**STAFF RECOMMENDATION**  
**2038 Elliott Avenue**  
**July 19, 2019**

**Application:** New Construction – Addition  
**District:** Waverly-Belmont Neighborhood Conservation Zoning Overlay  
**Council District:** 07  
**Base Zoning:** R8  
**Map and Parcel Number:** 10510015400  
**Applicant:** Bo and Becca Cox  
**Project Lead:** Melissa Sajid, [melissa.sajid@nashville.gov](mailto:melissa.sajid@nashville.gov)

<p><b>Description of Project:</b> Application for the construction of a rear addition</p> <p><b>Recommendation Summary:</b> Staff recommends approval with the following conditions:</p> <ol style="list-style-type: none"><li>1. The addition be at least twenty feet (20') from the existing outbuilding per the design guidelines except for the two feet (2') wide portion near the garage door that is closest to the driveway;</li><li>2. Staff approve the roofing color, windows, trim, and a brick sample prior to purchase and installation; and</li><li>3. If relocated, the HVAC shall be located behind the house or on either side, beyond the mid-point of the house.</li></ol> <p>With these conditions, staff finds that the project meets Sections III and IV of the <i>Waverly-Belmont Neighb

# SITE PLAN

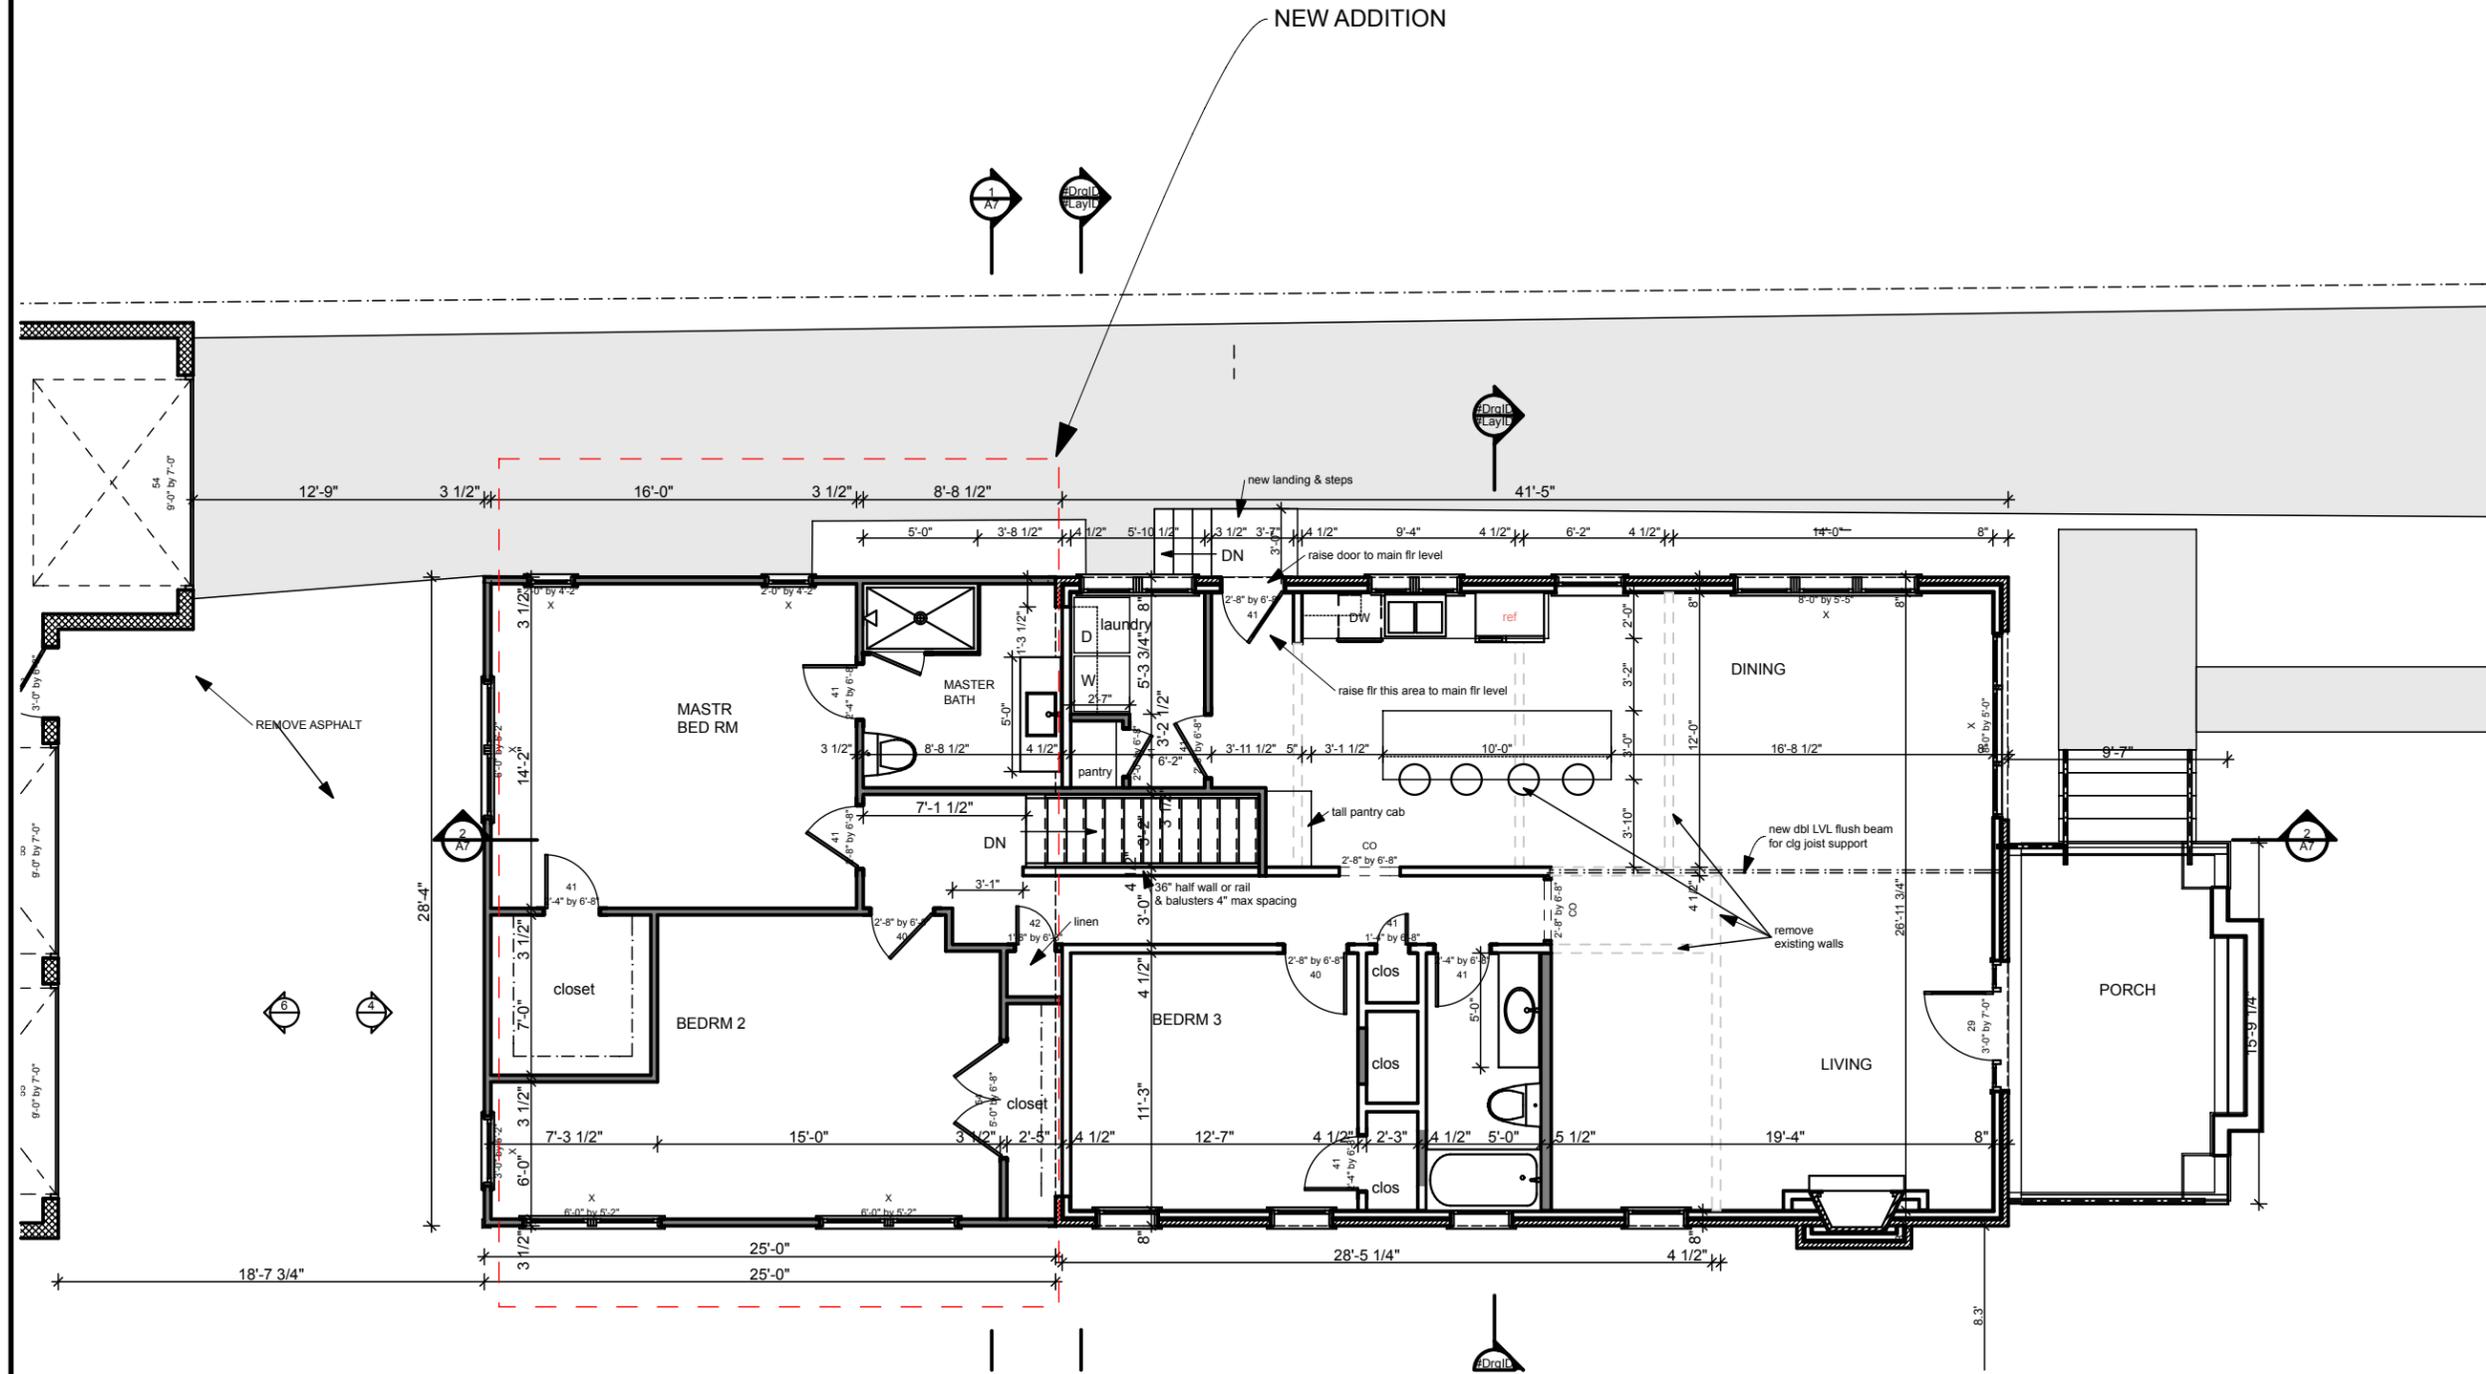
The site plan shows the addition located approximately eighteen feet, seven inches (18'-7") from the existing outbuilding with exception of the right rear corner, which is twelve feet, nine inches (12'-9") from the garage door. Staff recommends that the addition be at least twenty feet (20') from the existing outbuilding per the design guidelines except for the two feet (2') wide portion near the garage door that is closest to the driveway. Since that part of the addition is such a small piece of an already modest addition, staff finds that it could be appropriate. The applicant has agreed to revise the plan to meet this condition.

With the condition that the addition be at least twenty feet (20') from the existing outbuilding per the design guidelines except for the two feet (2') wide portion nearest to the garage door nearest to the driveway, staff finds that the project meets Section III.C for setbacks.

1. The addition be at least twenty feet (20') from the existing outbuilding per the design guidelines except for the two feet (2') wide portion near the garage door that is closest to the driveway;
2. Staff approve the roofing color, windows, trim, and a brick sample prior to purchase and installation; and
3. If relocated, the HVAC shall be located behind the house or on either side, beyond the mid-point of the house.
